30 CC STRING TRIMMER/BRUSHCUTTER CHANGES

HOMELITE' TECHNICAL SERVICE BULLETIN

NO 193-002

SPROCKET & DRUM, GUIDE BAR AND CHAIN

NEW WHEEL ARM ASSEMBLY WITH 1 INCH 20MM AND 22MM INTERCHANGABLE ARBORS A49429C 12" WHEEL ARM ASSEMBLY A49550B 14" WHEEL ARM ASSEMBLY

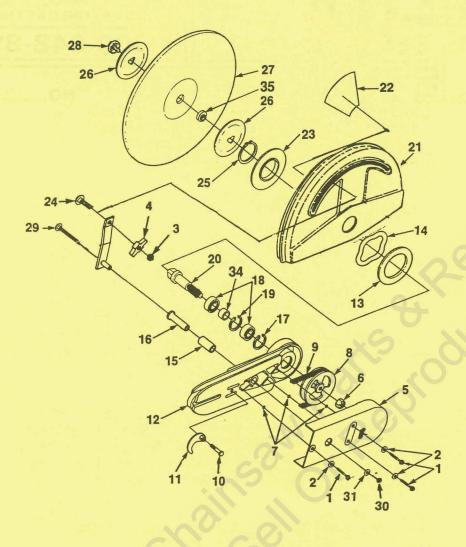
A new wheel arm assembly has been shipped with twelve and fourteen inch XL98D multipurpose saws, since the middle of December.

The easiest way to recognize the new assembly is by checking the flange washers. There are no holes in the new flange washers to accommodate a spanner wrench. There is a hole in the arm cover so that a tool may be inserted to lock the pulley, allowing easy removal of the bolt that holds the blade in place.

BP 250 BLOWERS

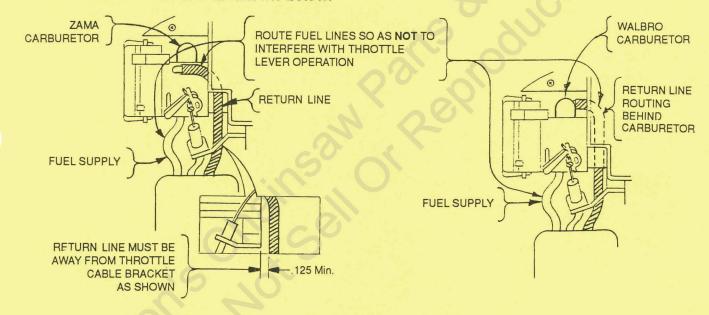
The above blowers may require re-routing of the fuel return line to prevent contact with the cylinder or crankcase.

Re-route the return line as shown below:
